MS No.: hess-2017-88 MS Type: Research article Special Issue: Coupled terrestrial-aquatic approaches to watershed-scale water resource sustainability Title: Title: Assessment of Integrated Watershed Health based on Natural Environment, Hydrology, Water Quality, and Aquatic Ecology Journal: Hydrology and Earth System Sciences

Anonymous Referee #1

Figure 1 Comparison of the observed and SWAT-simulated daily dam inflow during the calibration (2005–2009) and validation (2010–2014) periods at (a) HSD, (b) SYD, (c) CJD, (d) KCW, (e) YJW, (f) IPW, and (c) PDD.

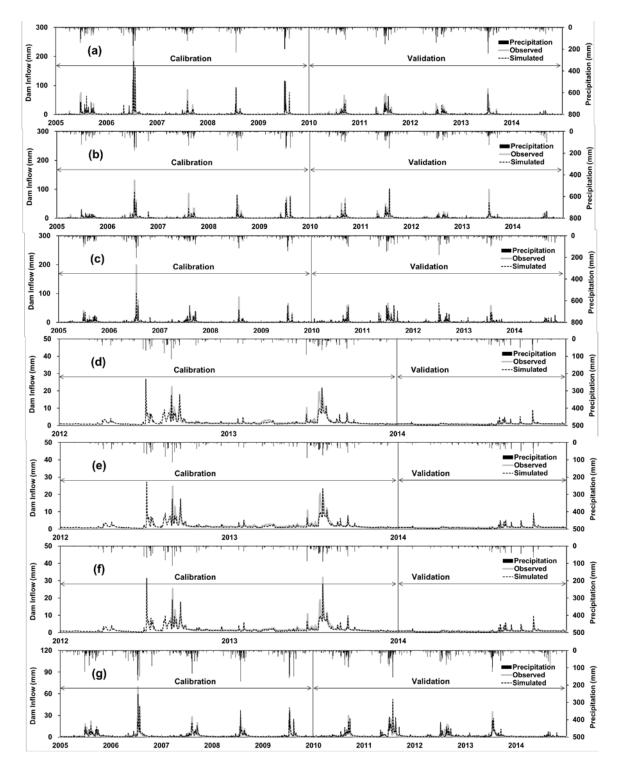
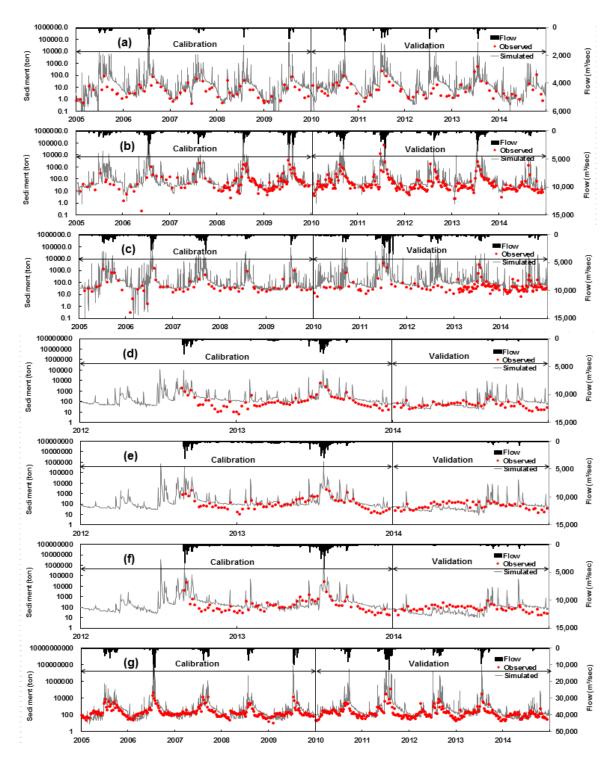
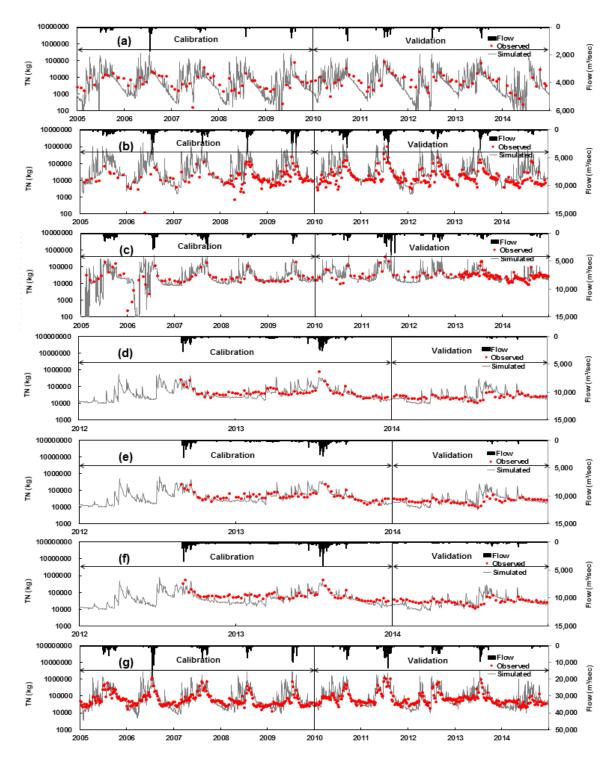
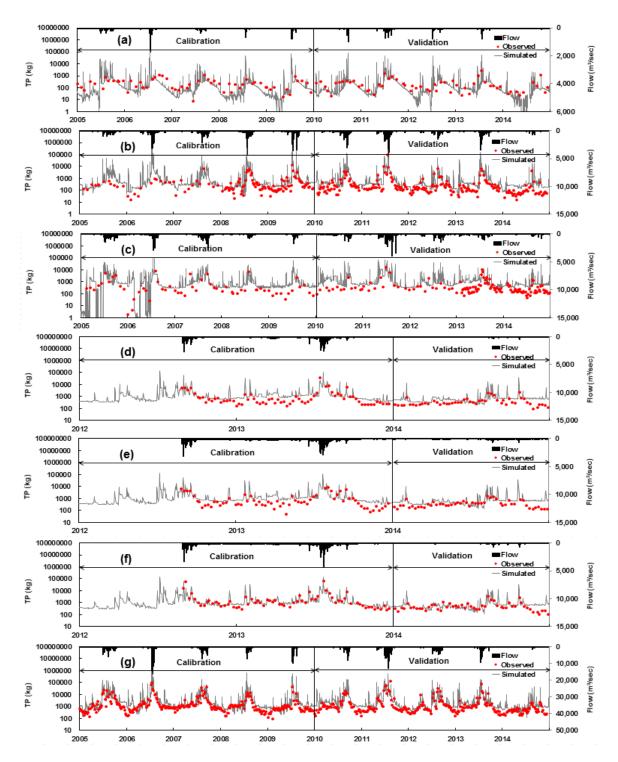
3. Is 90 m grid size DEM data sufficient to accurately simulate hydrology and water quality at such a large area? Is there any higher resolution elevation data can be used?

(Lines 206-207) Our study area included parts of North Korea. We have 30 m DEM covered by South Korea, but we don't have data in North Korea. Therefore, we used a world 90 m DEM from the Shuttle Radar Topography Mission (SRTM) of the International Centre for Tropical Agriculture (CIAT). As shown in the below figures 1, 2, 3, and 4, the results for hydrology and water quality were reasonable. I think that precipitation has an even greater impact on the hydrologic simulations than the DEM resolution does. In addition, the resolution of 90 m DEM deems appropriate for simulating the watershed hydrology for the 237 sub-watersheds (average area is 144 km²) using the SWAT model.
